International Aero Engines

INFORMATION BULLETIN

STANDARD PRACTICES - ENGINE - INFORMATION - ENGINE - OIL - TO ANNOUNCE THE AVAILABILITY

OF A NEW NL.4 SCAVENGE VALVE - CATEGORY CODE 7 - MOD.ENG-70-0380

Removal and Installation of the Spring Figure 1

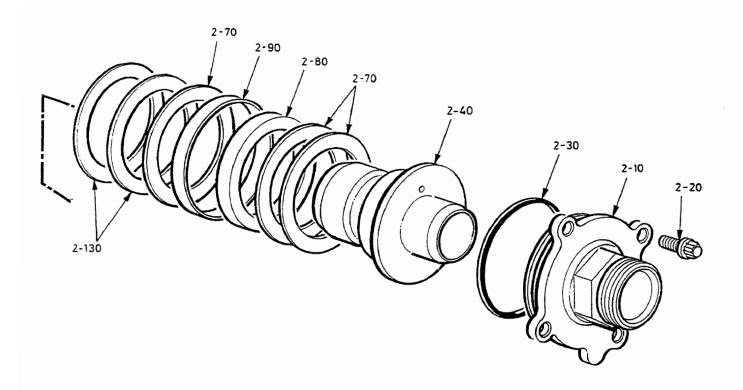
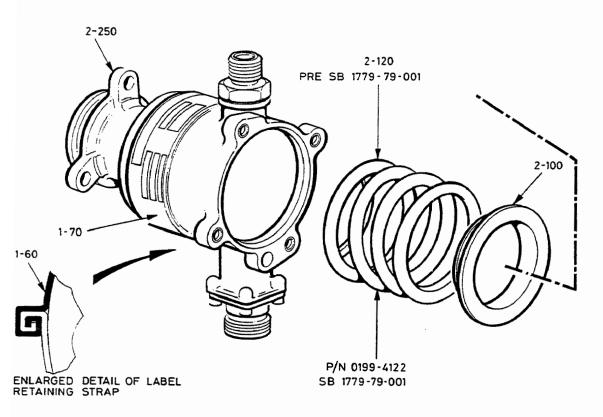
This Service Bulletin (Modification) introduces a new spring which has a lower working rate, achieved by increasing the number of working coils.

- A. Remove the No.4 Bearing Compartment Scavenge Valve Unit (Unit), as instructed by IAE Service Bulletin V2500-ENG-70-0380.
- B. Allow the oil to drain from the unit and install the transport blanks called up in CMM 79-25-41.
- C. Refer to CMM 79-25-41 and Figure 1 of this Service Bulletin and release the label retaining strap (1-60); remove the label retaining strap (1-60) and the identification plate (1-70) from the unit.
- D. Discard the label retaining strap (1-60) but keep the identification plate (1-70) until the Service Bulletin accomplishment is complete.

- E. Refer to CMM 79-25-41 and Figure 1 of this Service Bulletin, and remove the four machine bolts (2-20) which attach the valve cover (2-10); use the compression tool specified.
- F. Remove the toroidal sealing ring (2-30) from the valve cover (2-20).

- G. Remove the following components from the valve housing assembly (2-250):
 - (1) Valve piston (2-40)
 - (2) Spacer(s) (2-70)
 - (3) Magnet (2-80)
 - (4) Magnet sleeve (2-90)

- (5) Spacer (2-70) (if fitted)
 - (6) Spacer(s) (2-130)
 - (7) Spring seat (2-100)
- H. Remove the helical compression spring (2-120) and put aside; do not remove any other components from the valve housing assembly (2-250).

- Get the new helical compression spring (part no. 0199-4122) from the modification kit; assemble the spring, spring seat spacer and valve piston components as given in CMM 79-25-41. Use the original number of spacers at each location.
